Amendments to the Drawings

REMARKS/ARGUMENTS

FIG. 4

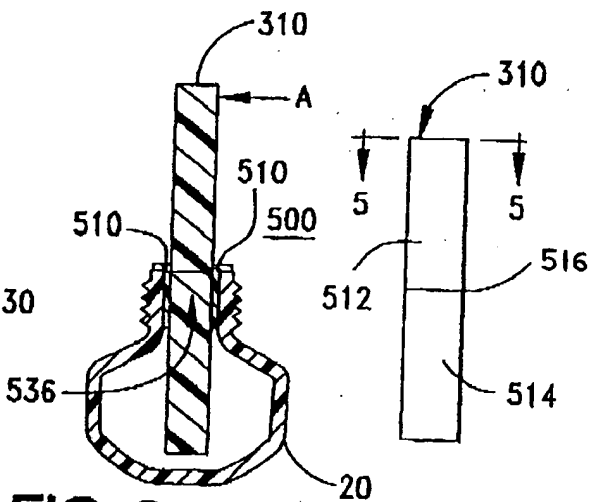
The attached sheet of drawings includes changes to Figure 4. This sheet, which includes Figures 1-5a, replaces the original sheet including Figures 1-5a. Figure 4 has been amended to add the reference numeral --516-- at the end of the lead line pointing toward the junction between wick segments 512 and 514. Support for this amendment may be found on page 5, lines 9-12 of the specification. This amendment corrects a clerical oversight in the original drawings and does not add new matter to the specification.

FIG. 4 of the drawings has been amended as explained in detail previously herein. This amendment is fully supported by the specification as originally filed and does not add new matter thereto.
